MFN 08-315

Docket No. 52-010

Subject: Response to NRC Request for Additional Information Letter Nos. 90 and 142 Related to the ESBWR Design Certification – Safety Analyses – RAI Numbers 15.4-28, 15.4-35 through 15.4-39

**Response to Portion of NRC Request for
Additional Information Letter Nos. 90 and 142
Related to ESBWR Design Certification Application**

Figure 1. Pressure and Water mass in the RPV Lower Head in accident scenario AS-2, no MSIV leak. This figure illustrates dry out of the Lower Head caused by high driving pressure across the BDL break.

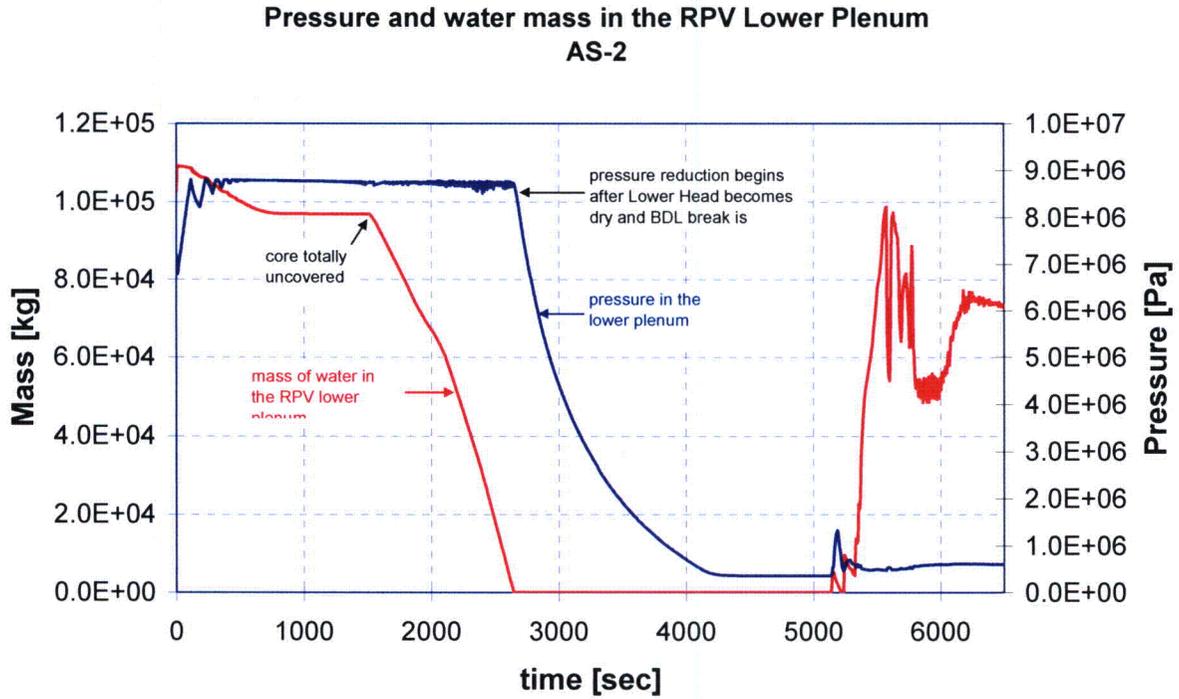
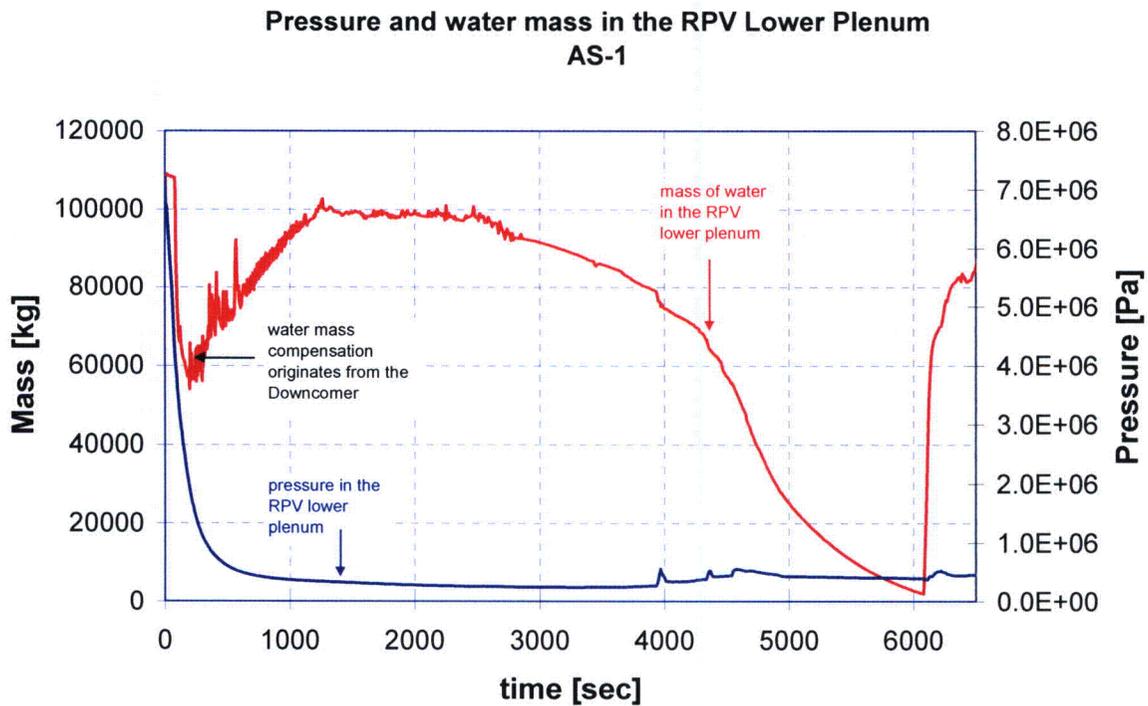
Research Report VTT-R-06771-07 (Part 3), Figures 7 and 14, show the calculated pH in scenarios AS-1 and AS-2 for the different CsOH formation rates, respectively. For AS-2, during the early stages of the accident, there seems to be a rapid increase in pH followed by a decrease, then a small increase followed by a sudden decrease (not shown). Finally, the pH seems to level off between 8 and 8.5. Please discuss the pH behavior in the RPV during the early stages (between 1000 and 10,000 seconds) of scenario AS-2. In addition, given that scenario AS-2 is similar to AS-1, and that the pH behavior is similar for all of the other pools in AS-1 and AS-2, please discuss why the pH behavior in the RPV during AS-2 is different from the pH behavior during AS-1.

The information discussed in this RAI was updated in Revision 2 to VTT-R-06671-07, "Estimation and Modeling of Effective Fission Product Decontamination Factor for ESBWR Containment – Part 3," which was transmitted to the NRC via MFN 07-466, Supplement 1, dated March 31, 2008. The pH behavior described in this RAI also appears in the revised calculations for Revision 2 of the Part 3 report. pH analysis for the RPV in AS-2 is not appropriate for the time period from 2436 seconds to 5145 seconds following the break. Section 8.1 of the revised report explains that MELCOR calculations indicate that the RPV is in "dryout" conditions. It is the lack of water in the lower head of the RPV that causes the erratic behavior predicted in the earlier revision of the "Part 3" report. The MELCOR calculations for AS-1 indicated that the lower head of the RPV does not dry out prior to reflooding due to the lower driving pressure. The other pools' behavior is not significantly different since the driving head of the RPV pressure has little impact on pool parameters.

As seen from the attached Figure 1 of the MELCOR run (of "Part 3" Revision 2), the lower head of the RPV becomes completely dry at approximately 2600 s in the accident scenario AS-2. This is caused by the high-pressure difference across the Bottom Drain Line Break junction. The similar plot from the MELCOR run of AS-1 (Fig. 2) shows that the early depressurization with ADS and DPV valves results in low pressure in the RPV Lower Head and thus lower driving pressure for water discharge from the RPV. In case AS-1, the Lower Head does not become empty during the balance of the simulation. The pH calculated by ChemSheet addresses the pH of the RPV water pool. MELCOR calculations indicate that the RPV is dry between 2436 s to 5145 s; therefore, the pH is calculation is not applicable since no pooling exists. This is the reason for discontinuity of the pH curve in case of AS-2.

Figure 2. Pressure and Water mass in the RPV Lower Head in accident scenario, AS-1, no MSIV leak. This figure illustrates the significantly lower driving pressure across the BDL break due to operating ADS, which also prevents dry out of the Lower Head in contrast to the case AS-2.
